# UNITED STATES PATENT AND TRADEMARK OFFICE

APPLICATION NO.	FILING DATE	FIRST NAMED INVENTOR	ATTORNEY DOCKET NO.	CONFIRMATION NO.
09/446,738	02/18/2000	YUVAL COHEN	B-3833PCT617	2829

<b>Office Action Summary</b>	<b>Application No.</b> 09/446,738	<b>Applicant(s)</b> COHEN ET AL.	
	<b>Examiner</b> Andrew Graham	<b>Art Unit</b> 2644

## **DETAILED ACTION**

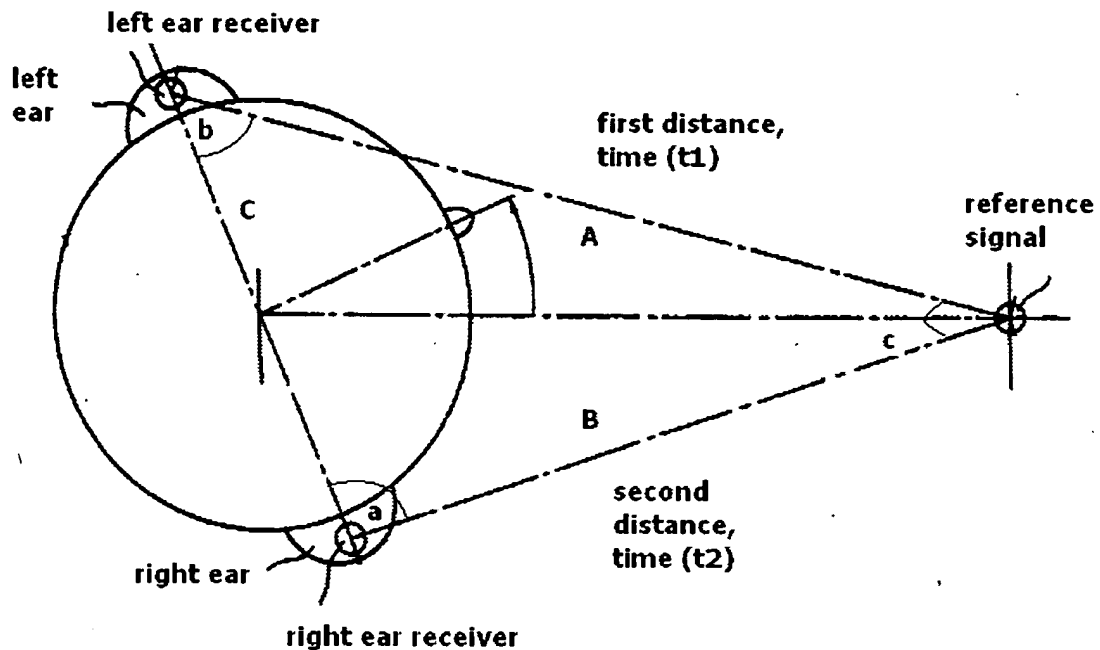
However, this disclosure does not enable one of ordinary skill in the art to which it pertains, or with which it is most nearly connected, to make and/or use the invention, as is further explained hereinbelow.

The general structure specified by the claims, as is supported by the specification is understood to be:

The specification states that the arrival times ( $t_1, t_2$ ) are processed to determine a phase difference (difference in terms of signal cycle of signals) so as to measure the distance (C) between a user's ears. The manner in which this is performed is not disclosed.

Appropriate correction or clarification is required.

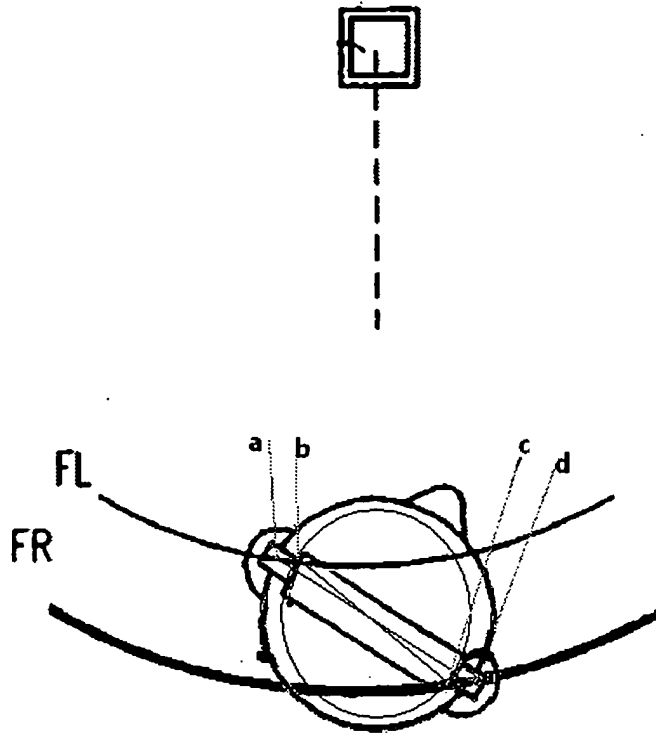
A related reference of Inanaga (EP 0438281 b1) utilizes the knowledge of the time of the emission of the reference signal to determine a distance to a user, based on the measured travel times of the reference signal to the two ears and an assumed sound velocity (col. 6, lines 10-28). This enables sides (A) and (B) of the triangle shown above between the ears and reference source to be known. As noted by the applicant, this does not allow a distance between the ears to be determined. The reason for this can be discerned through

the consideration of relevant rules of trigonometry pertaining to the side lengths and angles of a triangle. The Law of Sines requires a side length, the angle opposite the side length, and the length or angle of the unknown side to determine the angle or length of the unknown side. The Law of Cosines requires, for a unique triangle to be determined, all three side lengths or two side lengths and the angle adjoining the two known side lengths in order for the angles or the remaining unknown side length to be determined. The times and a sound velocity do not present the system of Inanaga with an angle or the means for calculating an angle.

However, the reference of Inanaga is able to determine a relevant angle of orientation through the use of a value for a radius of the user's head, as is shown in the equation that determines the angular orientation of a user's head (col. 6, lines 39-54). The source of this radius value is not disclosed.

This radius is important because the same sets travel distances, and hence signal travel times, may correlate to different angular orientations of different sizes of heads. For example, as generally shown in the figure below, a smaller width of a user's head (inner circle) correlates to the same radius or travel distance of sound (along lines FL,FR), but reaches the ears of the user at a different angular orientation, as indicated by the angular difference between the lines between points (a) and (d) (larger head) and the line between points (b) and (c). For larger head diameters, the reception

angle of this sound source would appear closer to perpendicular to the axis between the ears of a user in the illustration below.

Regarding the present application, only the arrival times are disclosed as the source of the processing of the measured distance. This is less information than present in the system of Inanaga, yet greater function is claimed. Phase differences would present interaural time difference, as is known in the art to relate to direction, but this measurement, alone, does not present enough information for the width of the space between the two receivers to be determined. It is the function or derivation of this greater function that is not considered enabled in the present application to allow one
